STANDARD PRACTICES - ENGINE - INFORMATION - ENGINE - STARTING - TO ANNOUNCE THE  
AVAILABILITY OF A STARTER WITH AN OIL SIGHT GLASS FEATURE - CATEGORY CODE 8 -  
MOD.ENG-70-0391

V2500-ENG-70-0391

## **STARTING – PNEUMATIC STARTER – INCORPORATE THE SIGHT PLUG**

80-2511  
Page 1 of 5

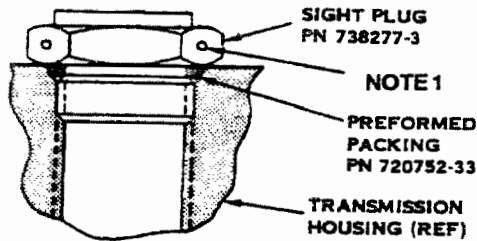
When this service bulletin is done, the unit is marked with the Sumitomo Products Co., LTD. (SPP) part number. Identify changed units by marking 790425A4 on the identification plate.

**Figure 1. Sight Plug Installation**

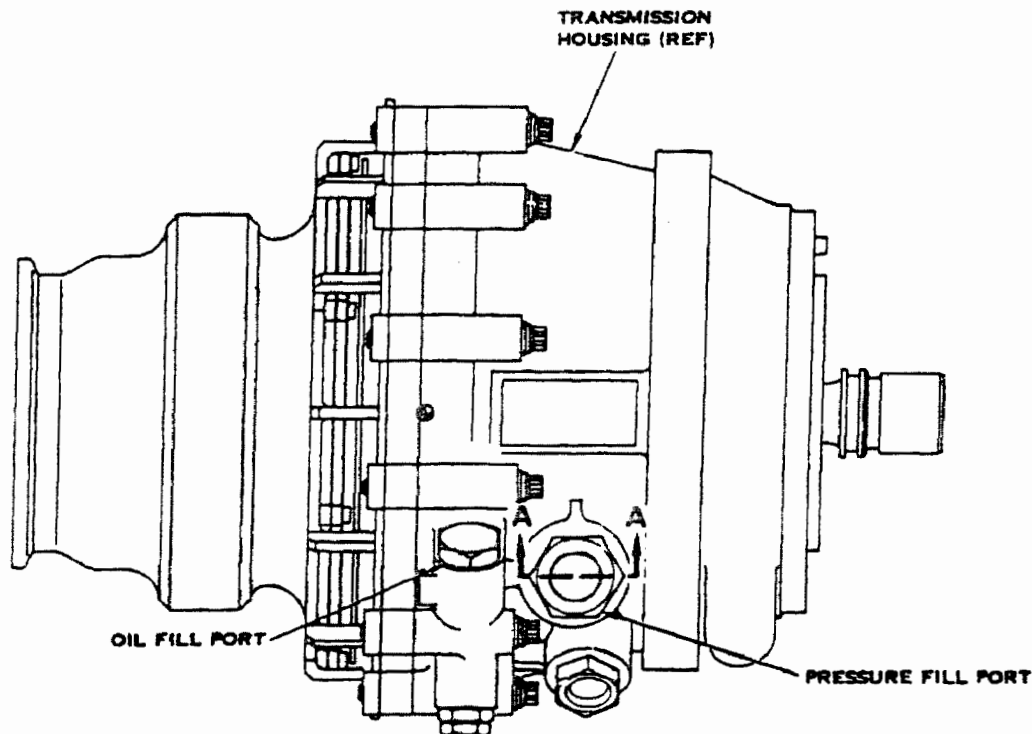
**A.** To change Pneumatic Starter part number 790425A3 to part number 790425A4, do these steps (refer to Figure 1):

- (1) Remove and discard adapter, part number 797845-1, and plug, part number MS9954-06.

- (2) Install new packing, part number 720752-33, onto sight plug, part number 738277-3.
- (3) Install sight plug into transmission housing pressure fill port. Refer to Figure 1.
- (4) Torque the sight plug to 45 to 60 pound-inches (5.09 to 6.78 Nm).
- (5) Remove and discard the oil fill instruction plate, part number 792997-1 .
- (6) Install a new oil fill instruction plate, part number 732229-1, as given in the ASSEMBLY procedures of the CMM.

- 1 LOCKWIRE SIGHT PLUG PN 738277-3  
TO TRANSMISSION HOUSING PER AS567
